To: T10 Technical Committee
 From: Rob Elliott, Compaq Computer Corporation (Robert.Elliott@compaq.com)
 Date: 26 June 2001
 Subject: SAM-2, [SPC-3](#), SPI-4, SBC-2 WAKEUP and reset cleanup

Suggested changes to SPI-4, SAM-2, SBC-2, and SPC-2 follow.

Figure 2 – SCSI power conditions flow control (automatic switching)

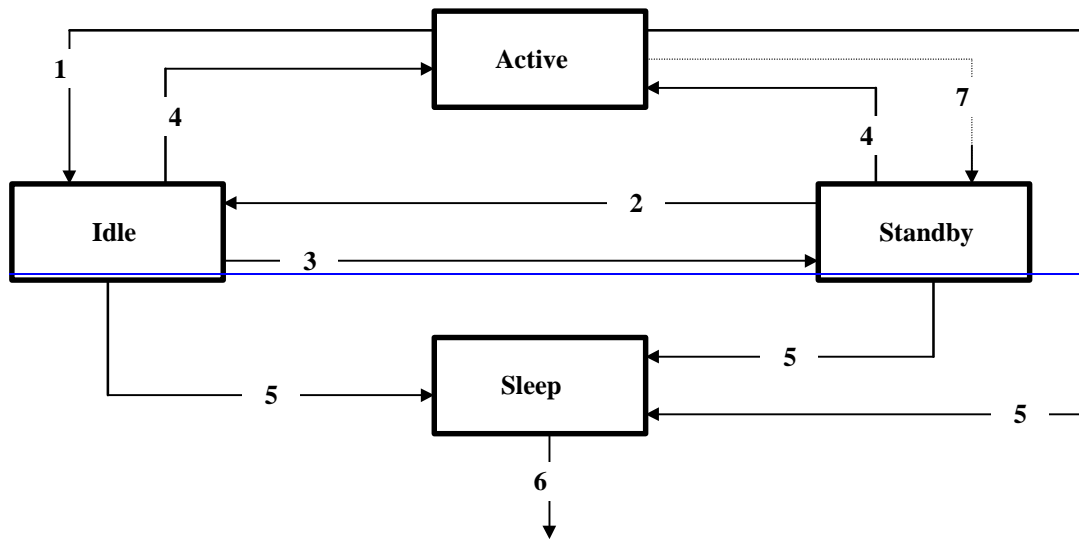
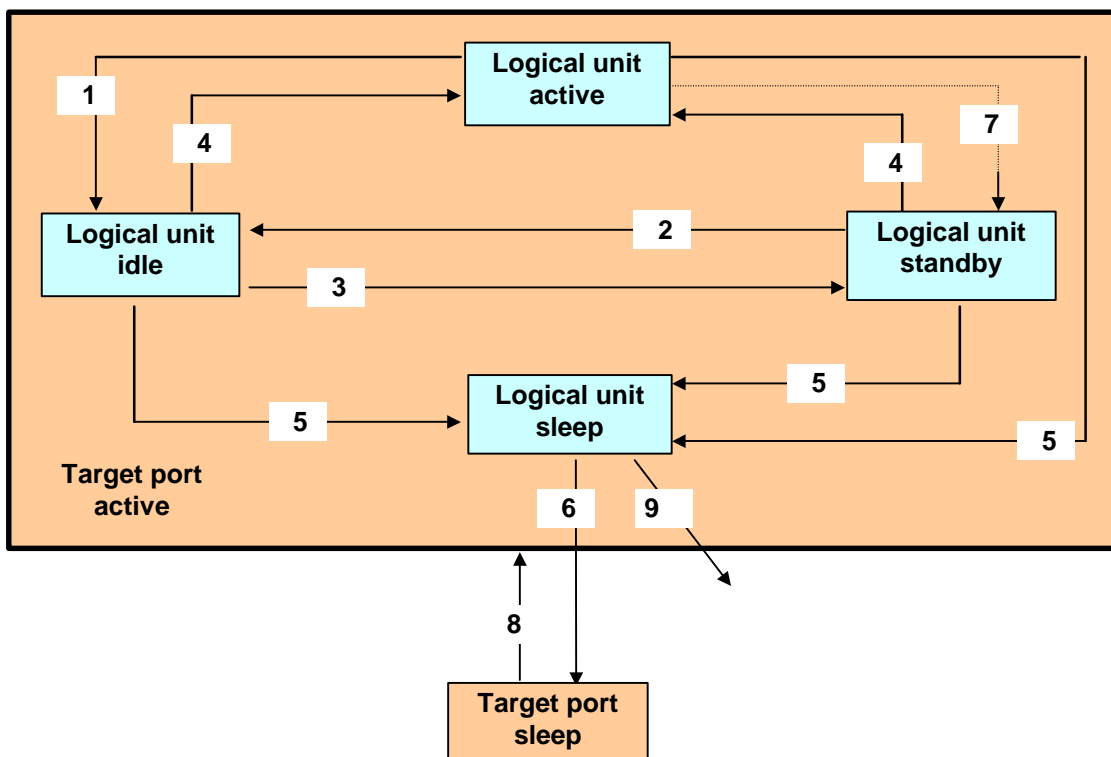
[Move SBC-2 section 4.2.1.5 modeling power conditions here. Due to extensive changes, change bars are not included.]

- Path 6: When all logical units in a target port reach the logical unit sleep power condition, the target port transitions to the target device sleep power condition.
- Path 7: A standby time-out when the idle bit is set to zero.
- Path 8: A wakeup or hard reset returns the target port to the active power condition and returns each logical unit to the power condition (active, idle, or standby) defined by the saved power condition mode page parameters.
- Path 9: A wakeup or hard reset returns the logical unit to the power condition (active, idle, or standby) defined by the saved power condition mode page parameters.

Figure 2 shows the transitions between the different power conditions in a logical unit and target port that are setup to adjust automatically to the power condition that allows any command to execute.

Figure 3 – SCSI power conditions flow control (controlled switching)

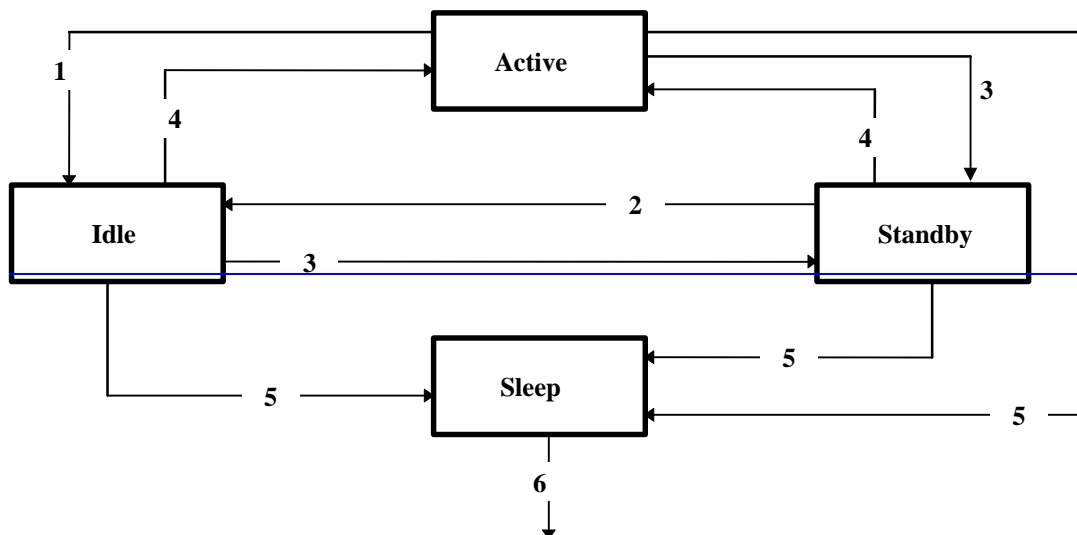
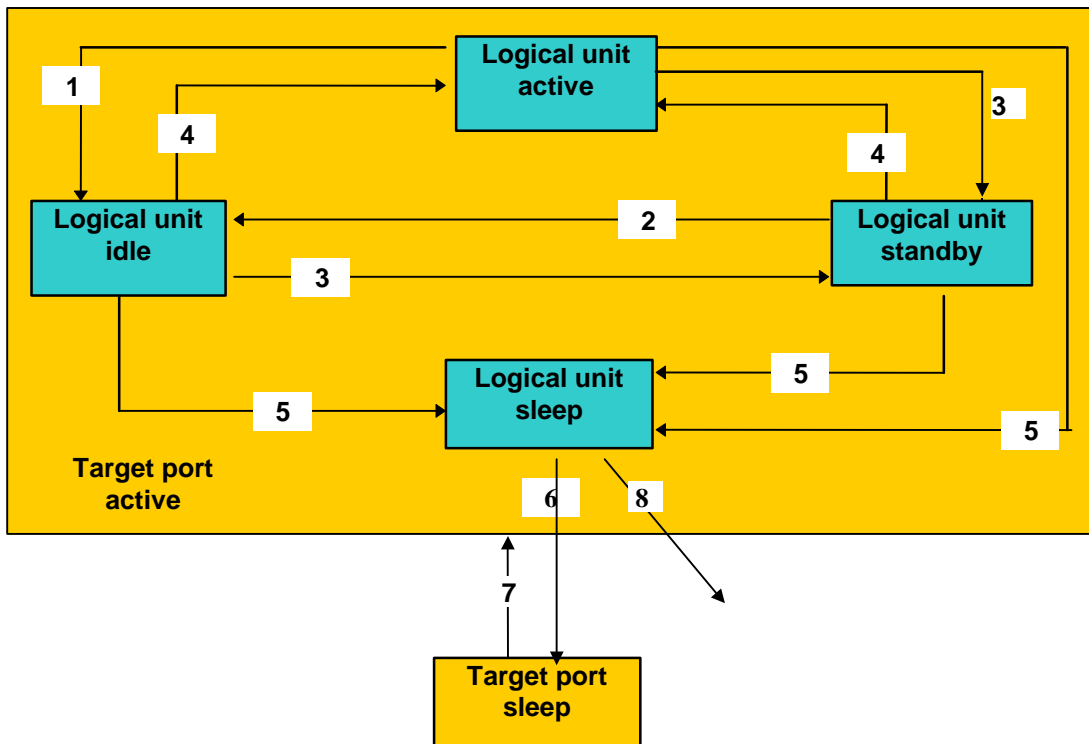
- Path 4: A START STOP UNIT command with a power condition code of 1h.
- Path 5: A START STOP UNIT command with a power condition code of 5h.
- Path 6: When all logical units to which a target port has access reach the logical unit sleep power condition, the target port transitions to the target port sleep power condition.

- Path 7: A wakeup or hard reset returns the target port to the active power condition and returns each logical unit to the power condition (active, idle, or standby) defined by the saved power condition mode page parameters.

- Path 8: A wakeup or hard reset returns each logical unit to the power condition (active, idle, or standby) defined by the saved power condition mode page parameters.

Figure 3 shows the transitions between the different power conditions in a logical unit and target port that are setup to only allow changing of the power condition by the application client. Any command received that requires more power than allowed by the current power condition shall be terminated with a sense key of ILLEGAL REQUEST and the additional sense code shall be set to LOW POWER CONDITION ACTIVE.
